Western Sub Regional RTEP: AEP Supplemental Projects

February 17, 2023

Changes to the Existing Supplemental Projects

AEP Transmission Zone: Supplemental Project S2098 Changes

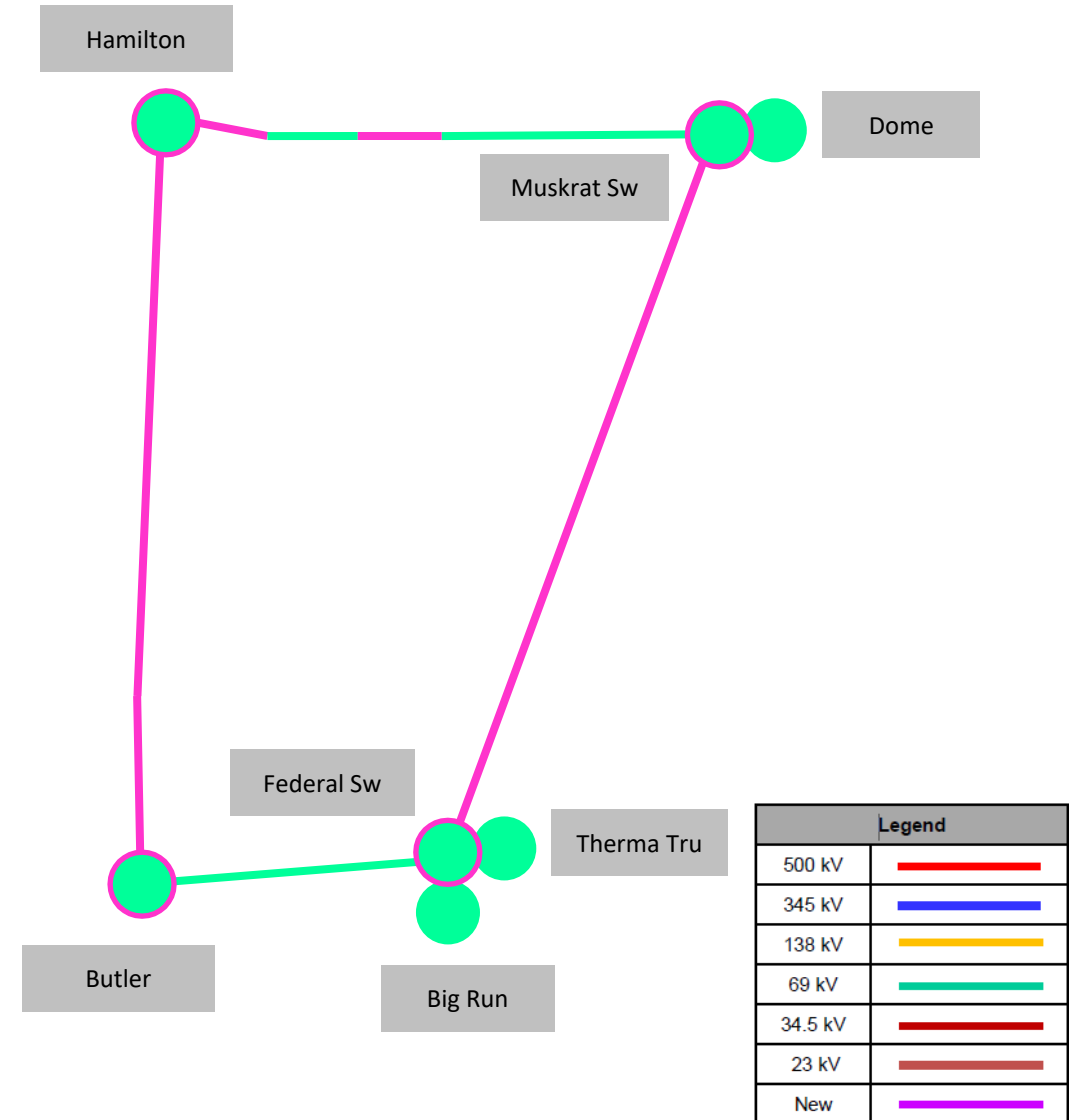
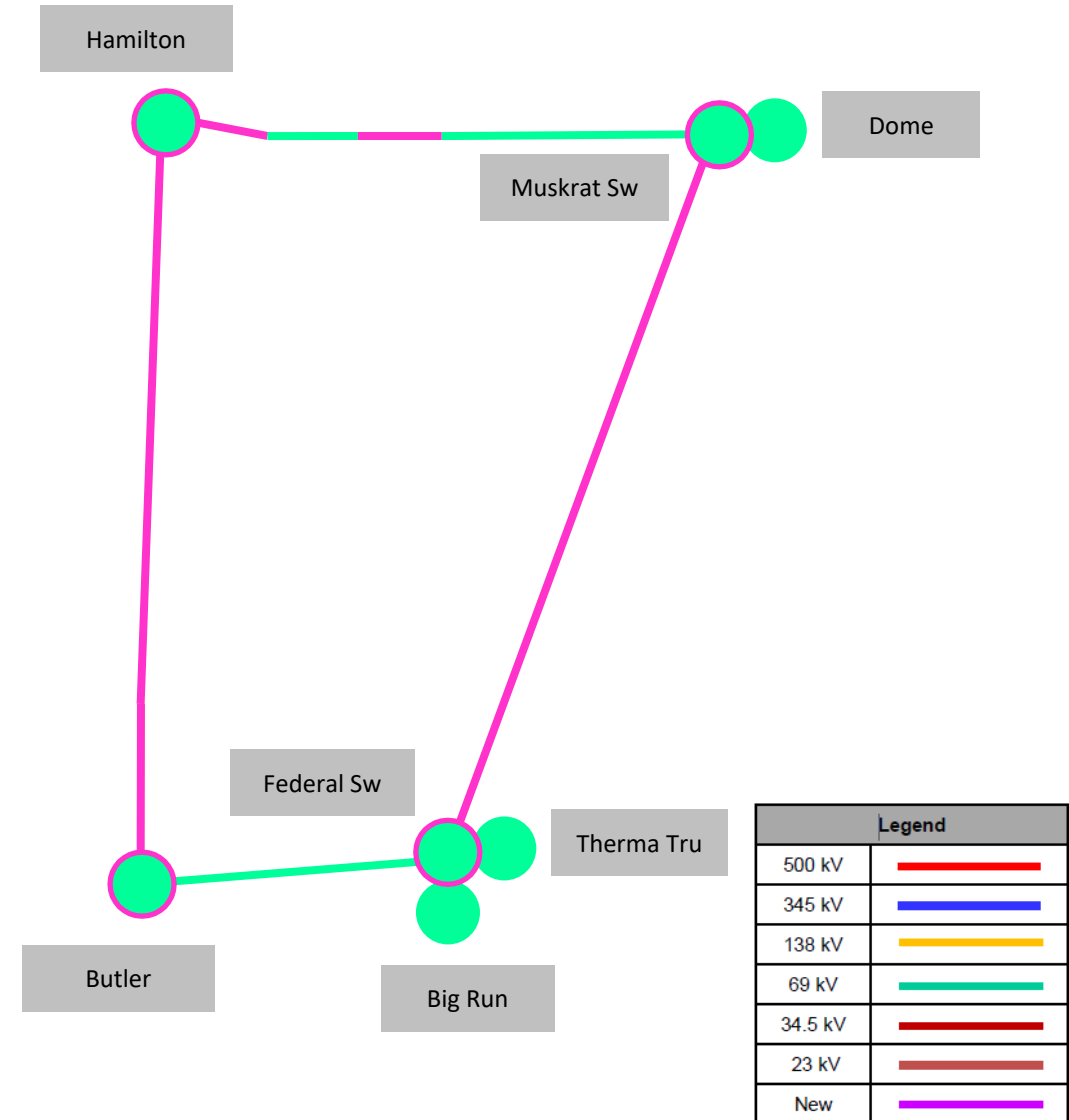
Reason for Changes: Hard tapped customer “Universal Tool” removed from transmission system. Basket Switch POP no longer needed

Rebuild 7.35 miles from Butler – ~~Basket Factory Switch~~ Hamilton 69kV with 556 ACSR. **(S2098.1) Estimated Cost: \$14.3M**

Install 8.37 mile long greenfield line with 556 ACSR from Federal Sw to Muskrat Sw to provide two way service to ~~University Tool~~, Hamilton and Dome Stations. **(S2098.3) Estimated Cost: \$13.0M**

~~Install 69kV phase over phase switch outside Universal Tool called Basket Factory Switch.~~ **(S2098.7) Estimated Cost: \$0.5M**

Total Estimated Cost: \$42.12 M ~~\$42.62M~~

AEP Transmission Zone: Supplemental Project S2401 Changes

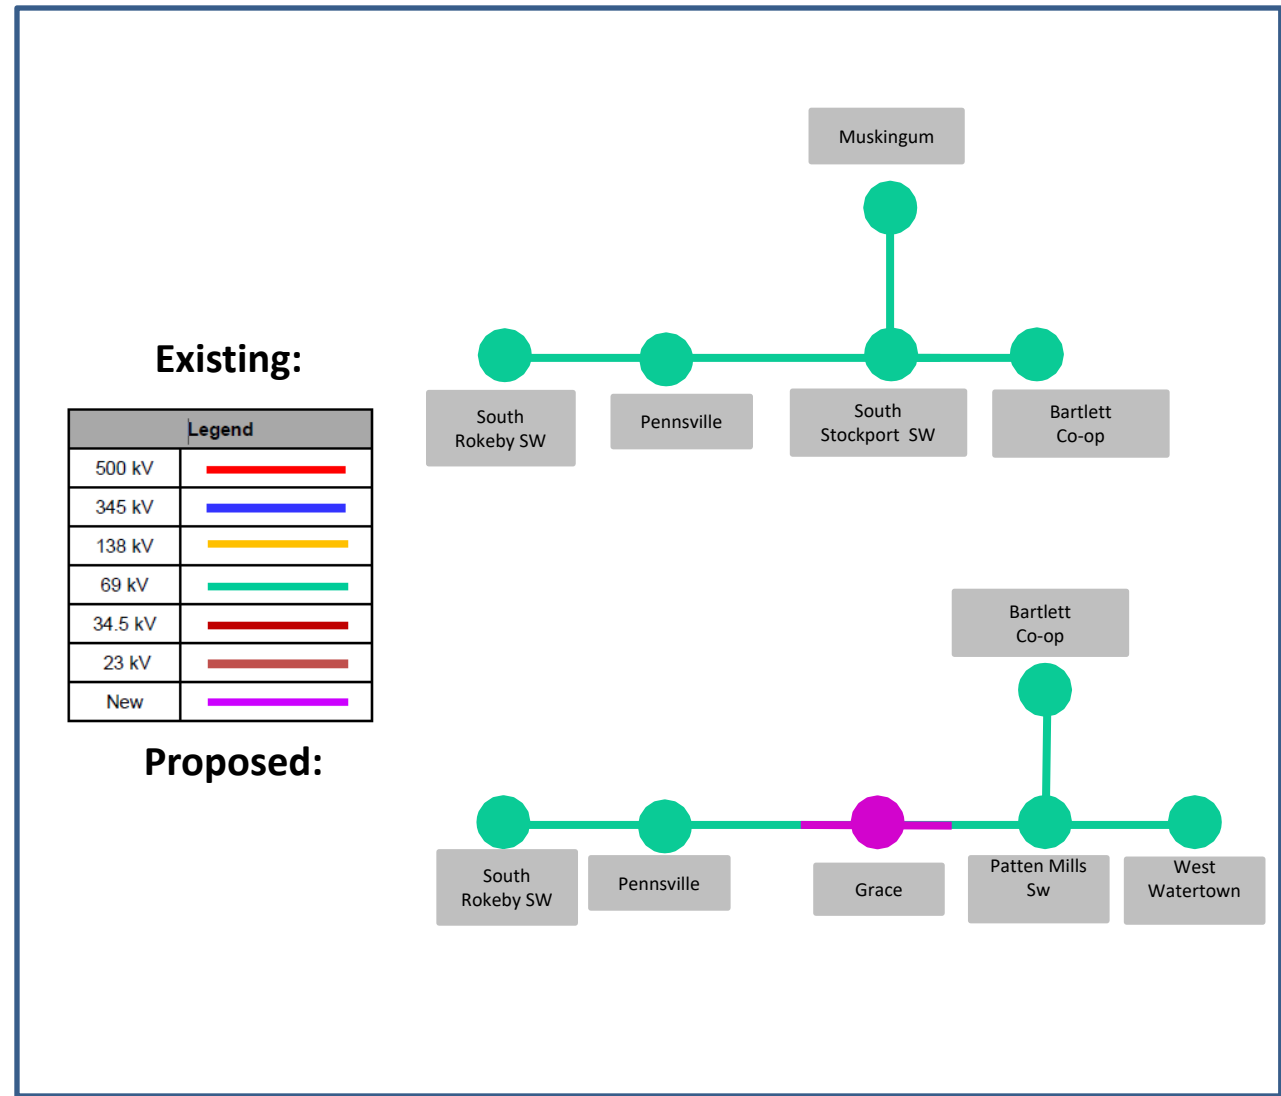
Reason for Scope Change: During detailed engineering it was determined that the terrain in the area would not allow for sufficient physical space to install the proposed three breaker ring bus configuration without significant amounts of civil improvements that were not initially anticipated. Therefore, the station design has been revised to a two breaker “in and out” configuration.

- Install a ~~3—3000A Breaker 69kV ring bus~~ a two breaker (3000A, 40 kA) 69kV straight bus station called Grace along the proposed South Rokeby – West Watertown 69 kV circuit (s2791) to serve the requested delivery point. **(S2401.1) Estimated Cost: \$2.3M \$1.8M**
- Remove the South Stockport Switch. **(S2401.5) Estimated Cost: \$0.07M**
- Install approximately 0.2 miles of 69kV line to tie the greenfield Grace station in-and-out to the Muskingum River – South Rokeby 69kV circuit. **(S2401.2) Estimated Cost: \$2.1M**
- Remove/Relocate approximately 0.05 miles of line on the Muskingum River – South Rokeby 69kV Line asset between structures 75 and 74A to accommodate the cut in to the new station. **(S2401.3) Estimated Cost: \$0.1M**
- Remote end work at South Rokeby Switch. **(S2401.4) Estimated Cost: \$0.9M**

Total Estimated Transmission Cost: \$5.4M \$4.97M

Projected In-Service: ~~5/1/2022~~ 6/12/2024

AEP Transmission Zone: Supplemental Project S2179 Changes

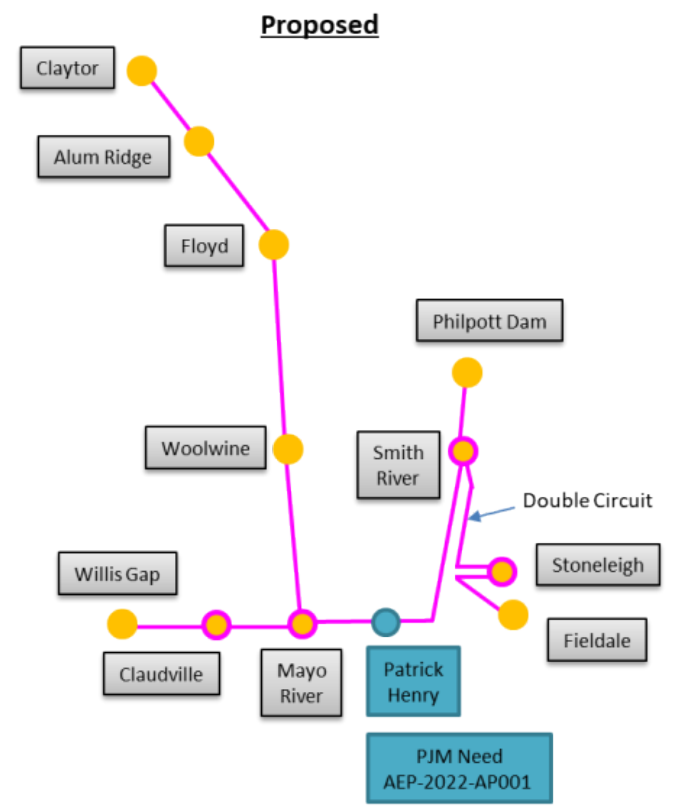
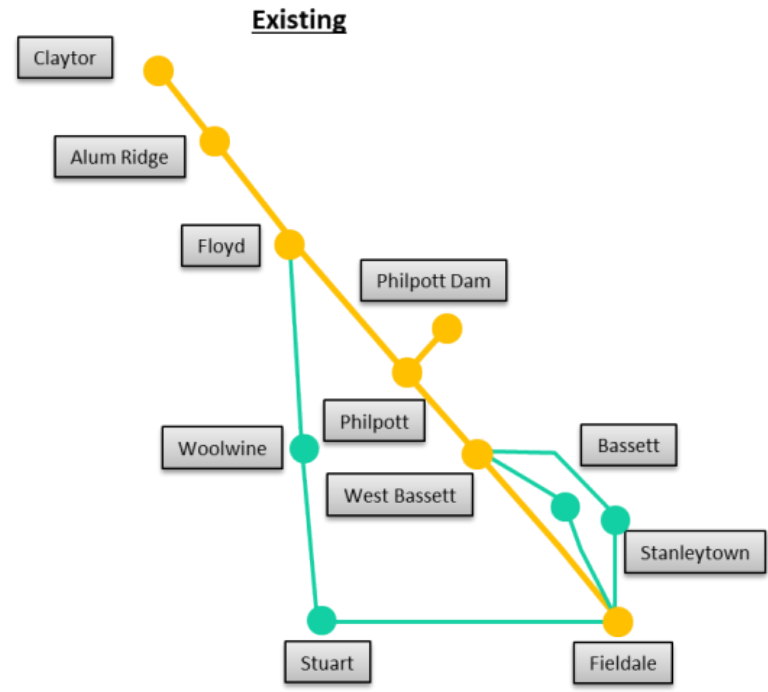
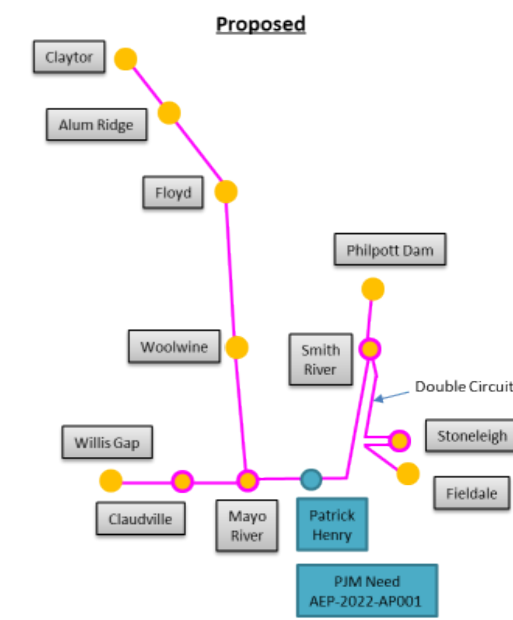
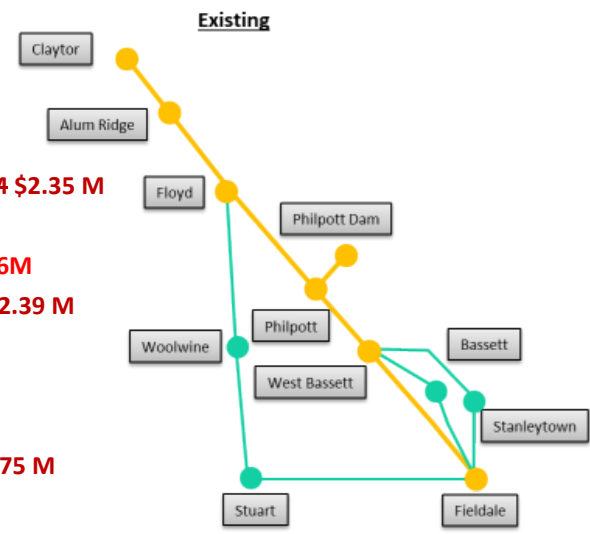
- As the Stuart Area Improvements Project has moved through functional and detailed scoping, updates to the scope of work have been made, although the electrical solution has remained the same. The lack of availability of new station property has impacted some of the scope of work. The replacement and conversion of the existing Stanleytown and Bassett substations has evolved into combining the substations into a new Stoneleigh station that will serve the former Stanleytown distribution load and Bassett distribution load will be served from the new Smith River substation. In addition, the former Salem Highway station has been renamed to Mayo River and the former Fairystone station has been renamed to Smith River.

- Construct ~12.5 miles 138 kV line from Alum Ridge to Claytor. (S2179.1) Estimated Cost: ~~\$34.3M~~ \$40.78 M
- Construct ~6.5 miles 138 kV line from Alum Ridge to Floyd. (S2179.2) Estimated Cost: ~~\$20.6M~~ \$23.85

- ~~Construct ~7 miles of 138 kV line from Fieldale-Fairystone. (S2179.3) Estimated Cost: \$17.6M~~
- Construct ~~~1.25~~ 0.4 miles of double circuit 138 kV line to connect Stanleytown Stoneleigh. (S2179.4) Estimated Cost: ~~\$5.3M~~ \$2.35 M

- ~~Construct 0.07 miles of 138 kV line from Bassett Switch-Bassett. (S2179.5) Estimated Cost: \$1.5M~~
- Construct ~~~1.2~~ 1.9 miles of 138 kV line from Philpott Dam-Fairystone-Smith River. (S2179.6) Estimated Cost: ~~(\$3.6 M)~~ \$6.86M

- Construct ~~~22~~ 12.5 miles of 138 kV line from Salem Highway-Claudville to Willis Gap. (S2179.7) Estimated Cost: ~~\$65.0M~~ \$42.39 M
- Construct ~11.4 miles of 138 kV line from Claudville to Mayo River. (S2179.35) Estimated Cost: \$38.87 M
